REFERRAL RESPONSE URBAN DESIGN

FILE NO: Development Applications/ 528/2016/1
ADDRESS: 13-15A Coolong Road VAUCLUSE
PROPOSAL: Construction of a new single dwelling house including a swimming pool, ancillary structures & associated landscaping and siteworks
FROM: Tom Jones Urban Design
TO: Mr D Booth

MAP 10 Vaucluse West Precinct

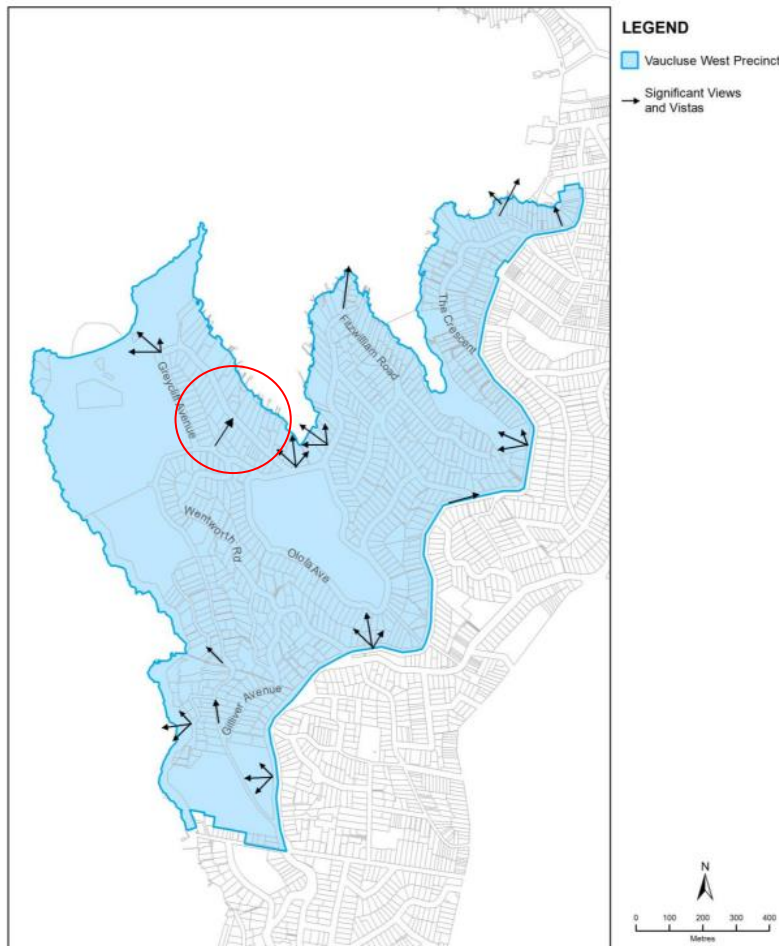
However the development blocks views of the Harbour from Nurrans Road. Chapter B3 also states that : *The built form should not detract from the unique features of the natural landscape, or be of such a scale that it dominates adjoining development, or is visually intrusive when viewed from the streetscape or the harbour.* The building is from an urban design perspective *of such a scale that it dominates adjoining development and is visually intrusive when viewed from the harbour.*

The proposed building on the amalgamated site blocks views of *the harbour* that are currently seen through *view corridors between buildings*. The view down Nurrann Road to the North east is identified on the precinct map as a *significant view*. See MAP 10 from WDCP2015 below. (circle is added)

The building does block views of the Harbour from public space. The pitched roofs which seem an unnecessary component of the design could be removed, this amendment would enable the proposal to both; retain more of the view from the public realm and largely comply with the height limit.
